Form 3160-5
(June 2019)UNITED STATES
DEPARTMENT OF THE INTERIOR
BUREAU OF LAND MANAGEMENTFORM APPROVED
OMB No. 1004-0137
Expires: October 31, 2021**SUNDRY NOTICES AND REPORTS ON WELLS**
Do not use this form for proposals to drill or to re-enter an abandoned well. Use Form 3160-3 (APD) for such proposals.5. Lease Serial No. **NMNM93207**

8. Well Name and No.
MIDNIGHT HOUR 10 FED COM/733H9. API Well No. **30-015-49812**10. Field and Pool or Exploratory Area
PURPLE SAGE; WOLFCAMP (GAS)11. Country or Parish, State
EDDY/NM**12. CHECK THE APPROPRIATE BOX(ES) TO INDICATE NATURE OF NOTICE, REPORT OR OTHER DATA**

EOG respectfully requests an amendment to our approved APD for this well to reflect the following changes:

Midnight Hour 10 Fed Com 733H API #: 30-015-49812

WELL LOCATION AND ACREAGE DEDICATION PLAT

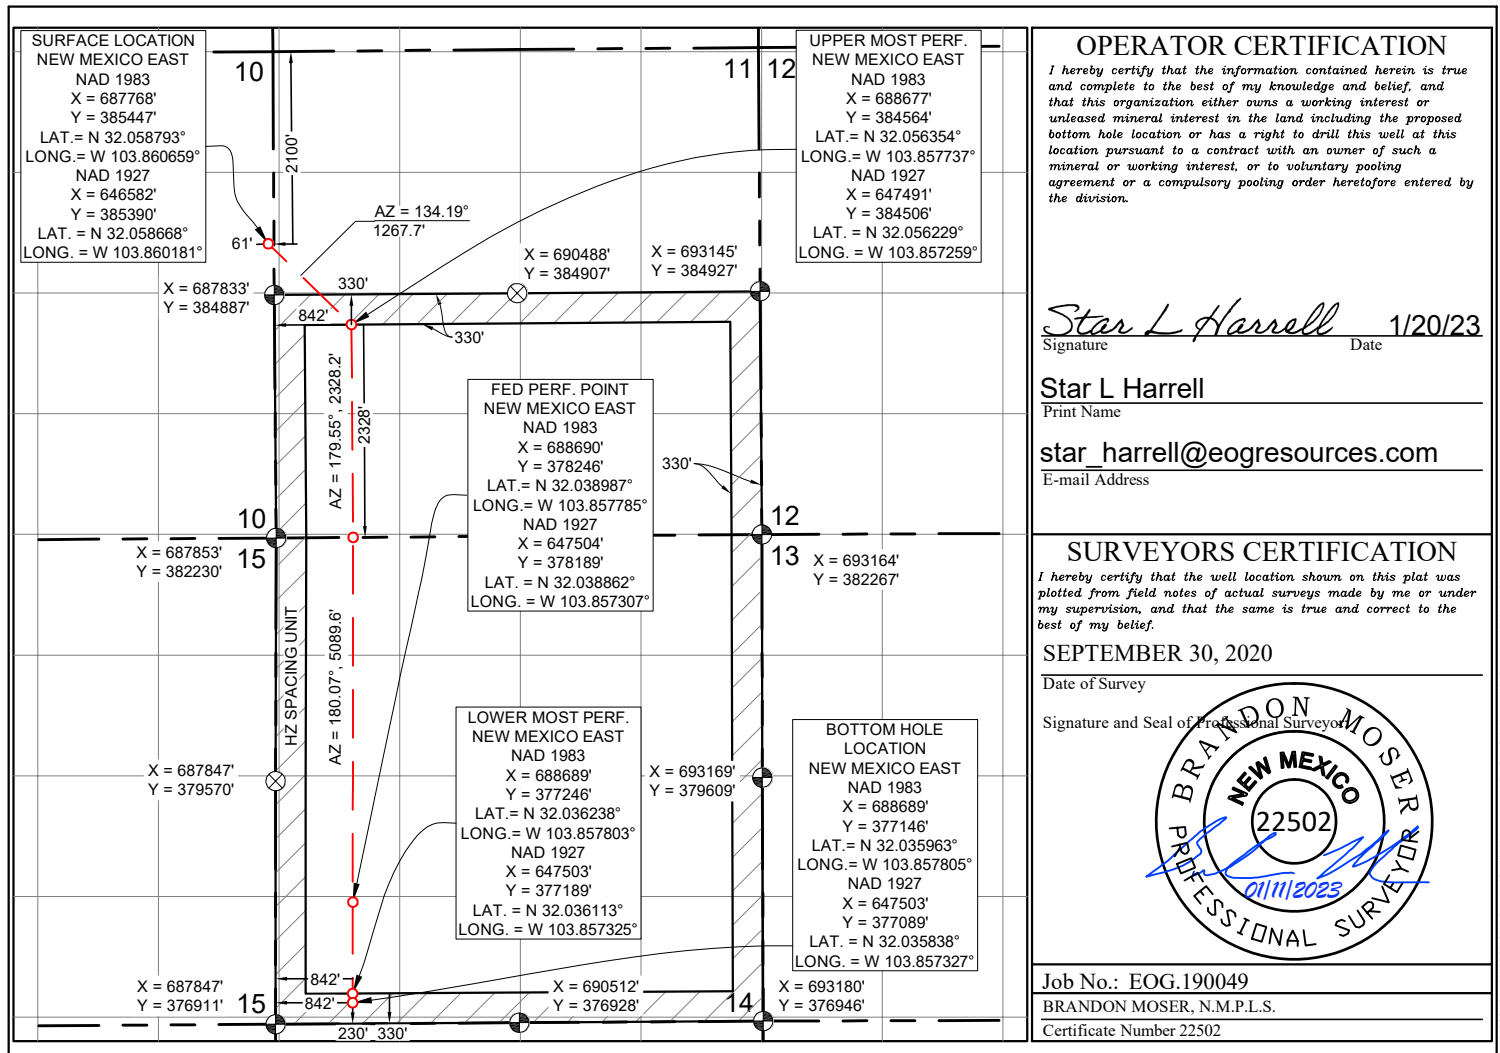
Change BHL from T-26-S, R-30-E, Sec 14, 230' FSL, 990' FWL, Eddy Co., NM, to T-26-S, R-30-E, Sec 14, 230' FSL, 842' FWL, Eddy Co., N.M.

UL or lot no.	Section	Township	Range	Lot Idn	Feet from the	North/South line	Feet from the	East/West line	County
M	14	26 S	30 E		230	SOUTH	842	WEST	EDDY
